**MAINE DEPARTMENT OF
INLAND FISHERIES AND WILDLIFE**

ADDENDUM NO. 1

**IMPROVEMENTS AT GRAND LAKE STREAM STATE FISH HATCHERY
GRAND LAKE STREAM, MAINE**

BGS PROJECT NO.: 3289-14

OXYGEN PAD STRUCTURAL PLAN AND SECTION

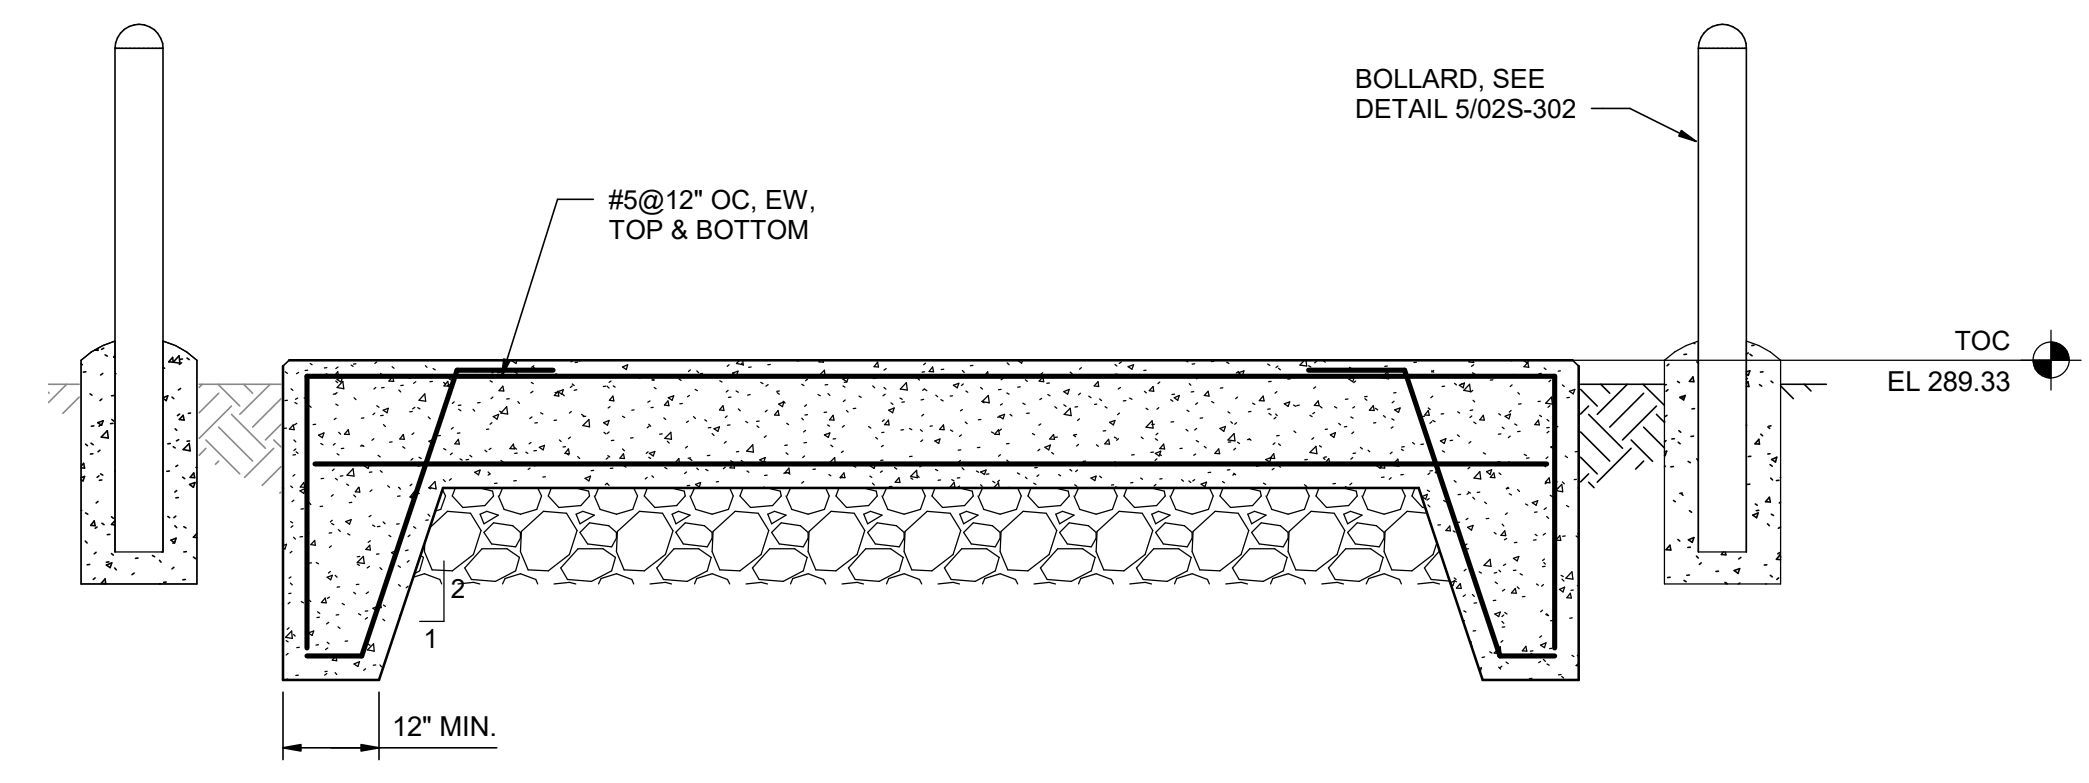
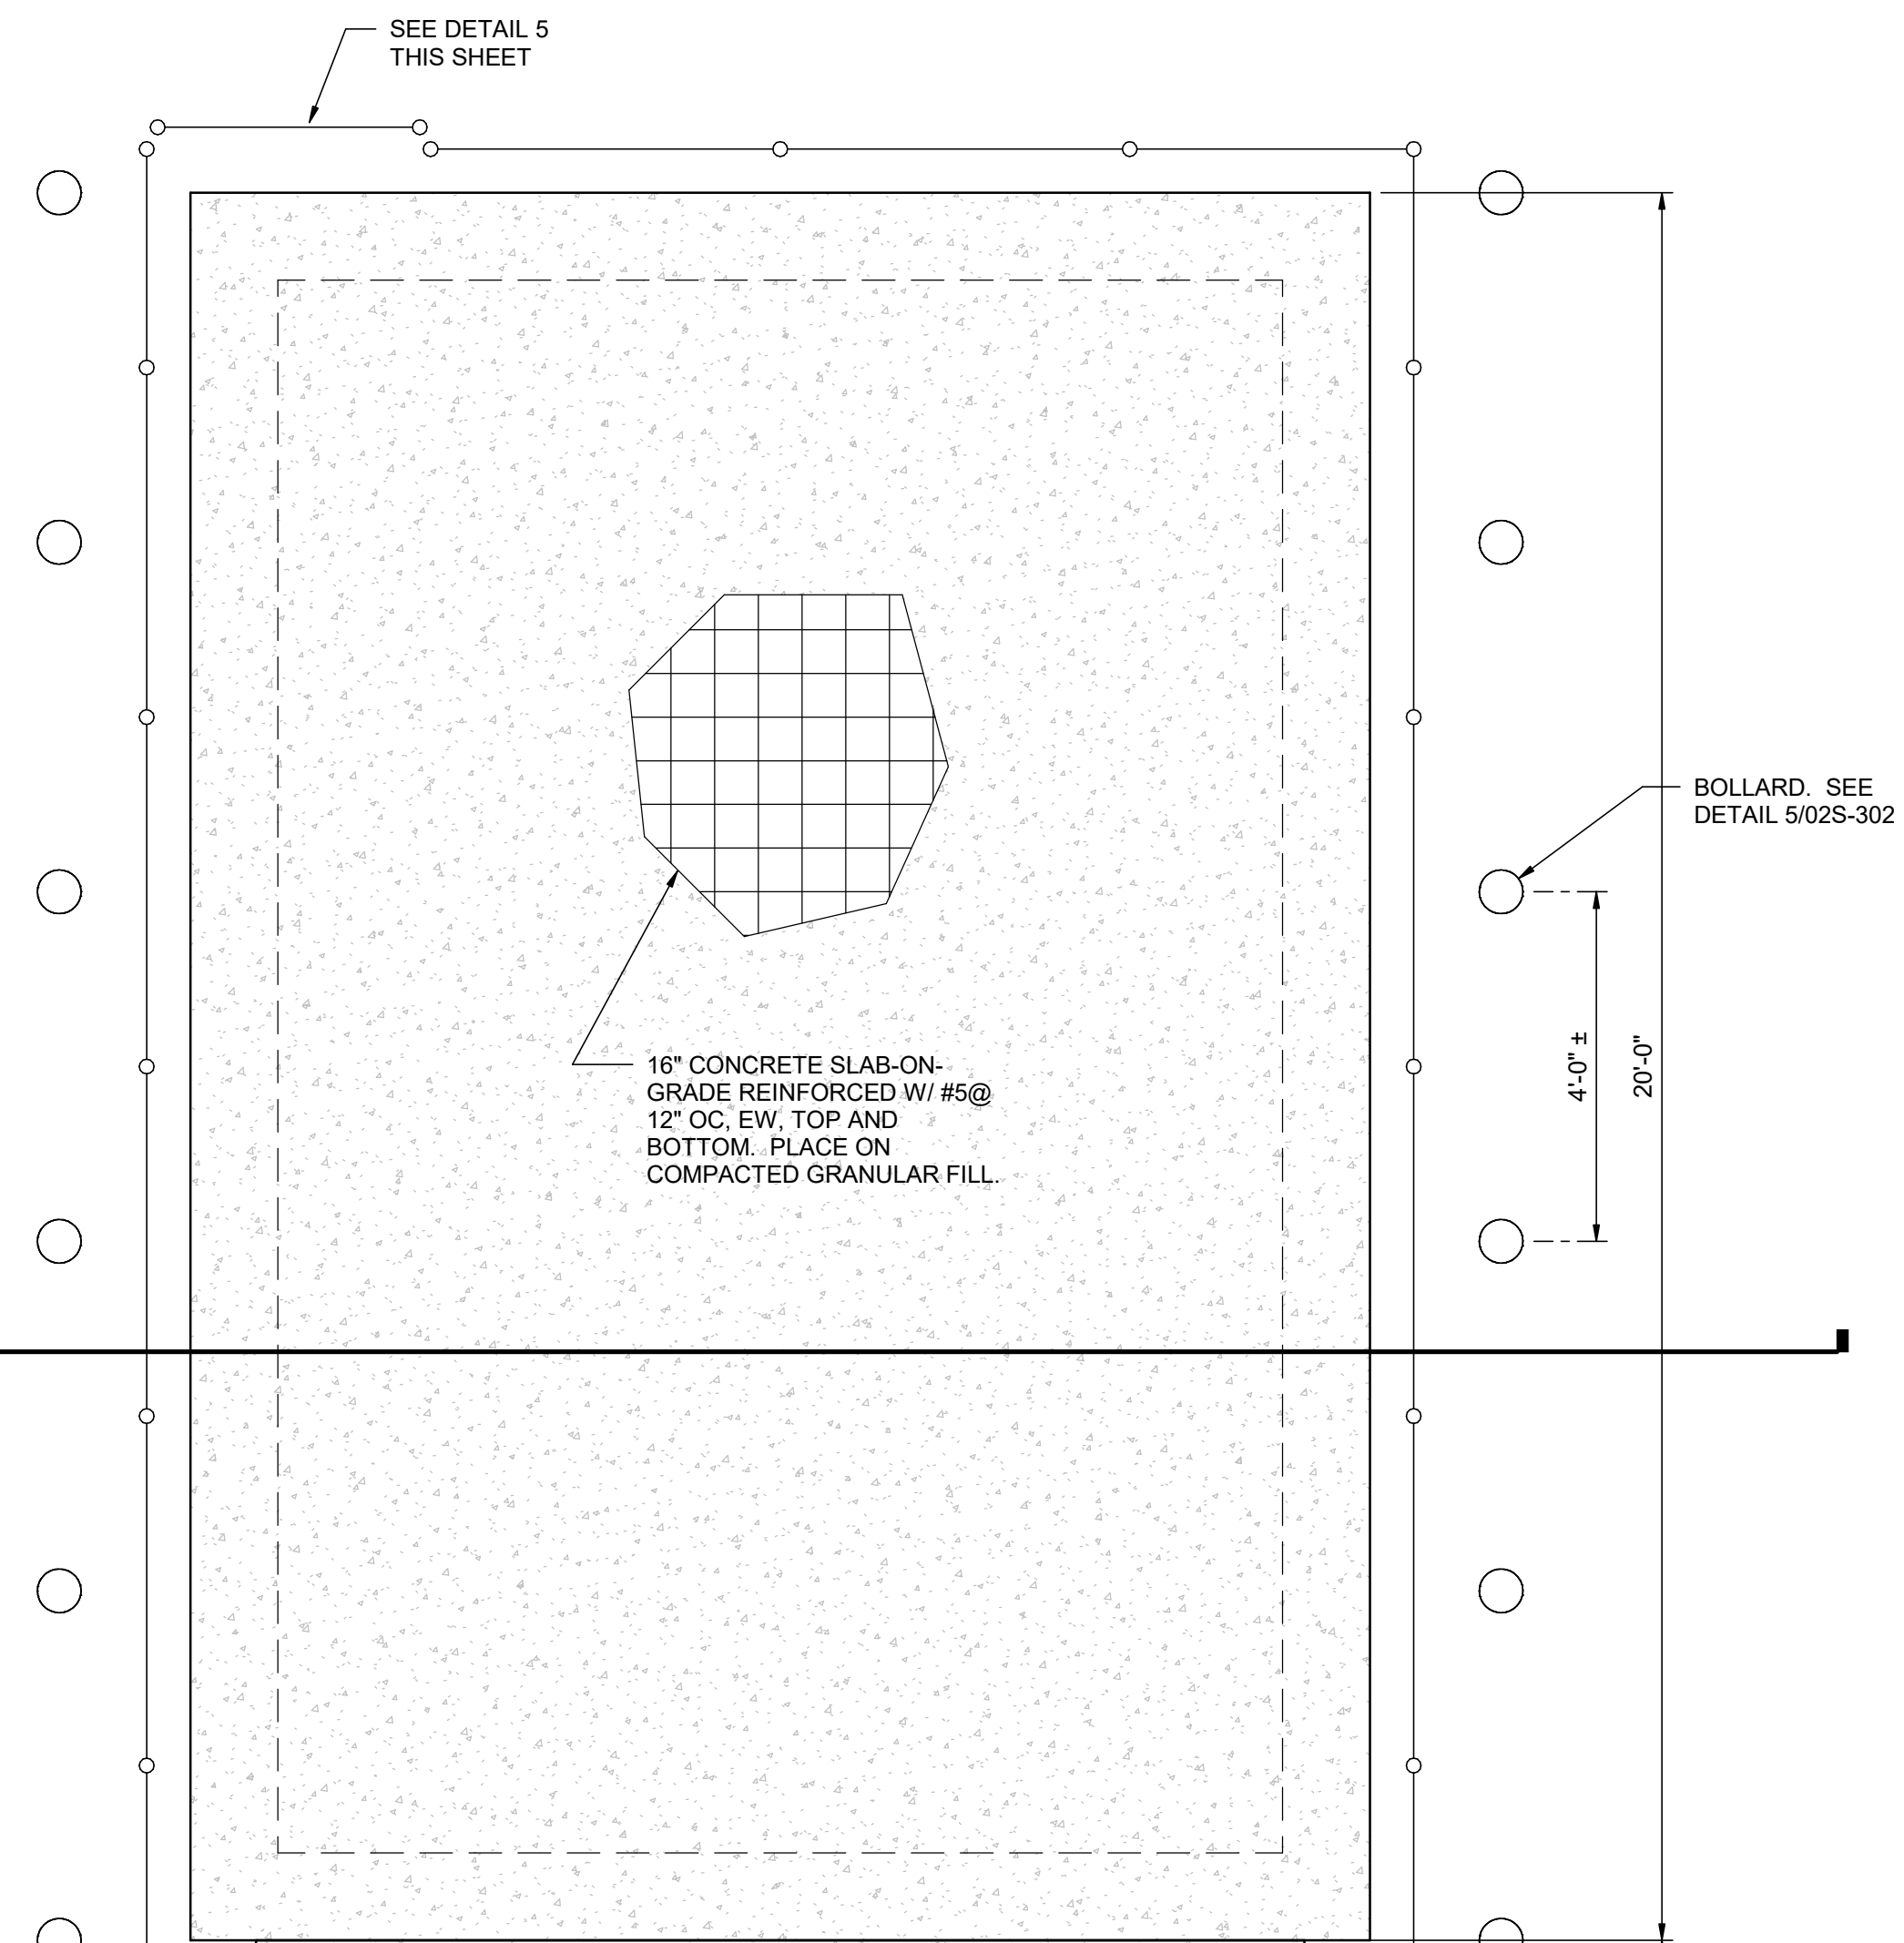
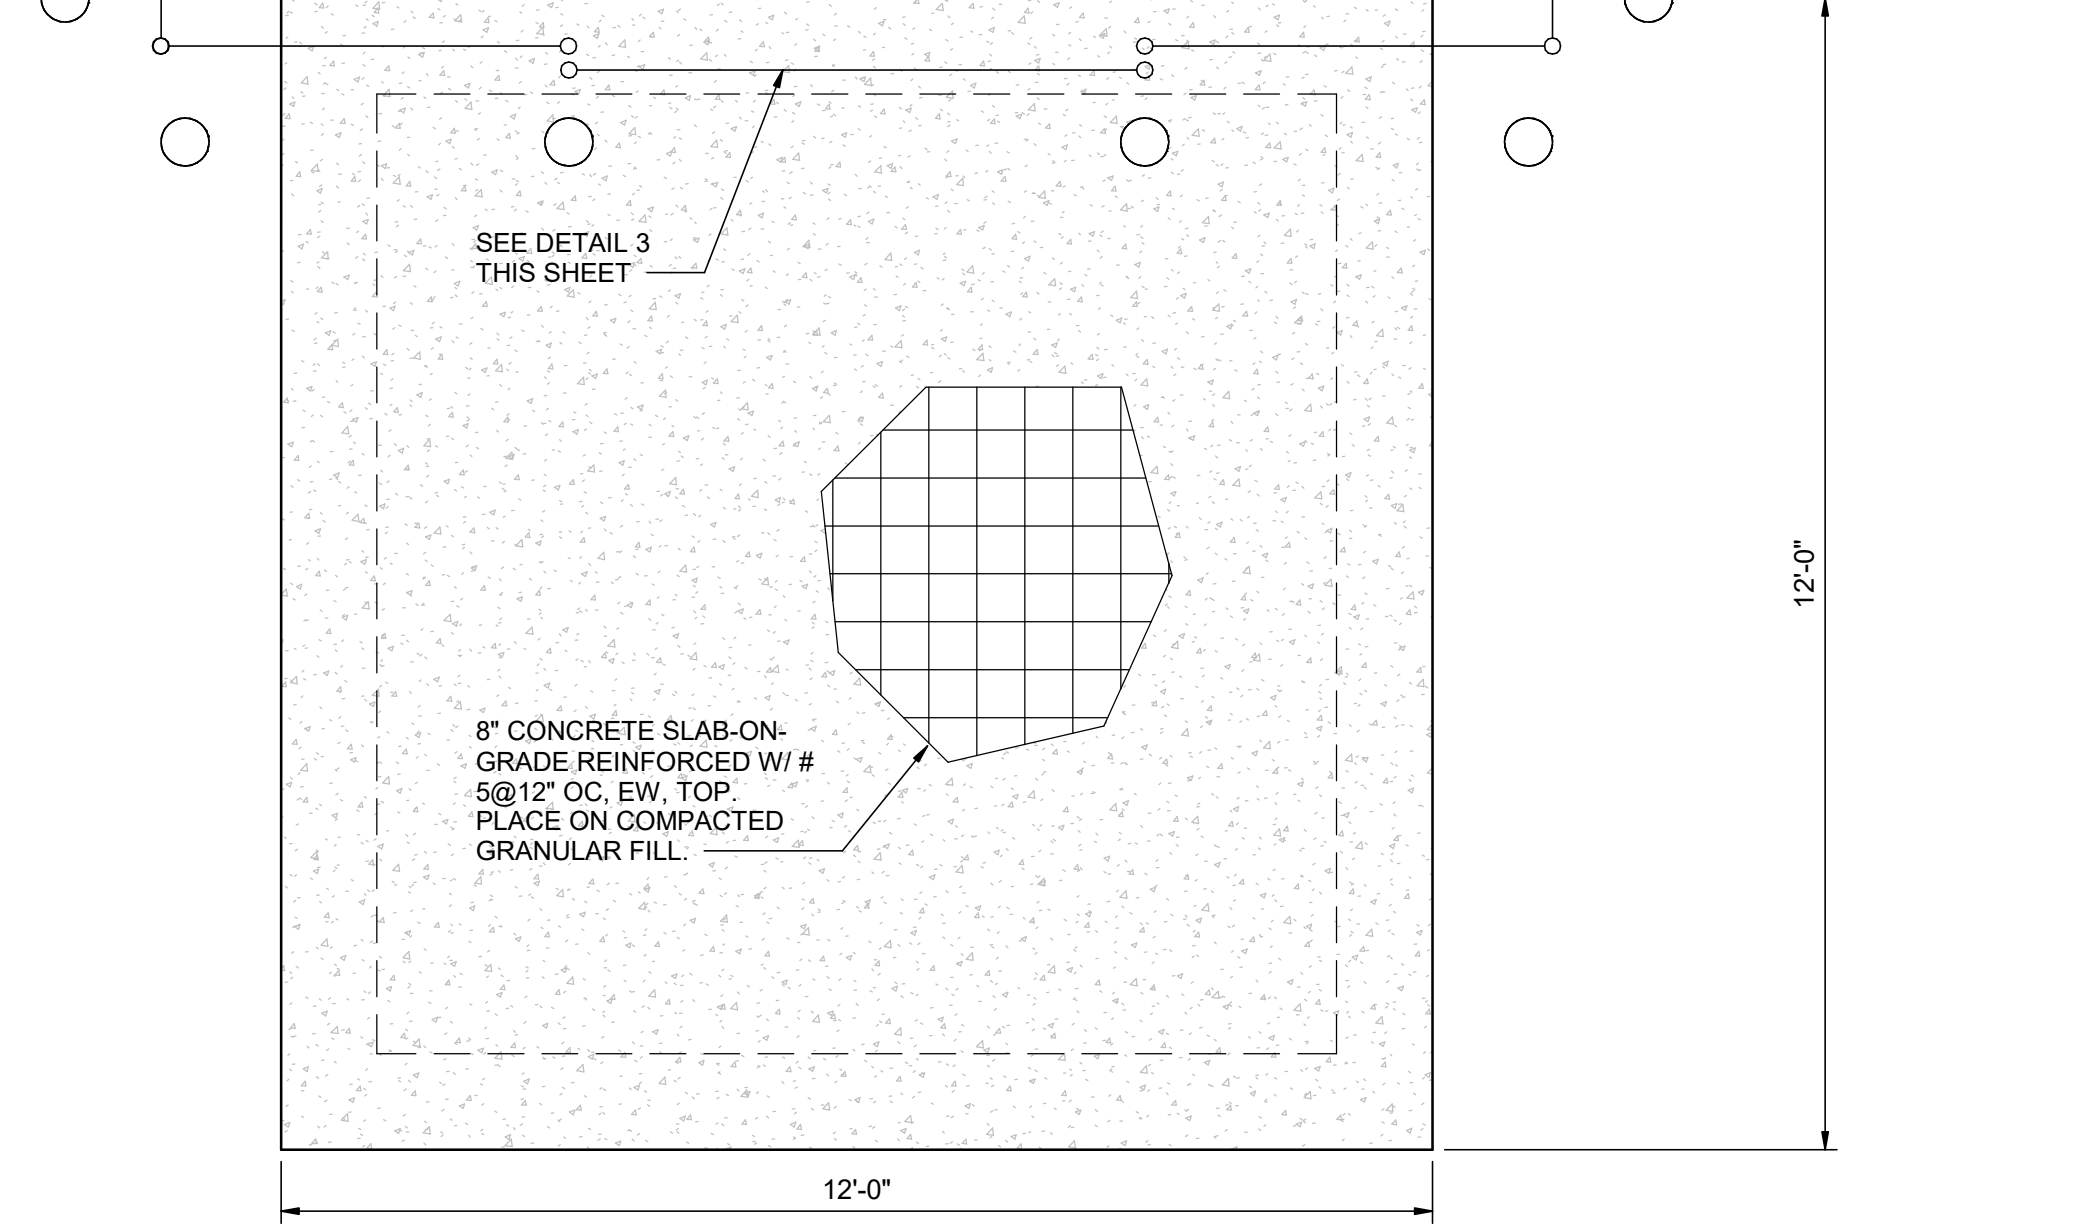
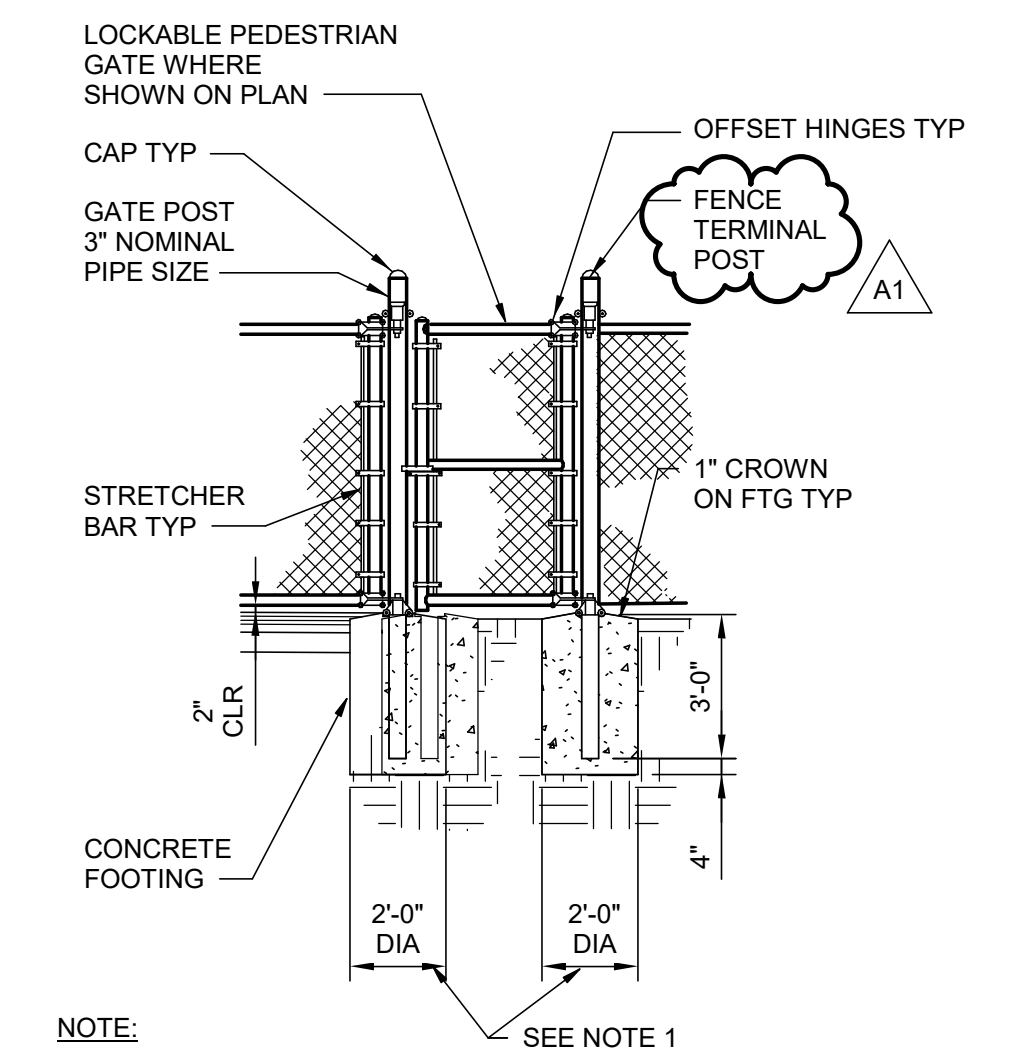
***UPDATE:** Sheet was updated to modify detail callouts.*
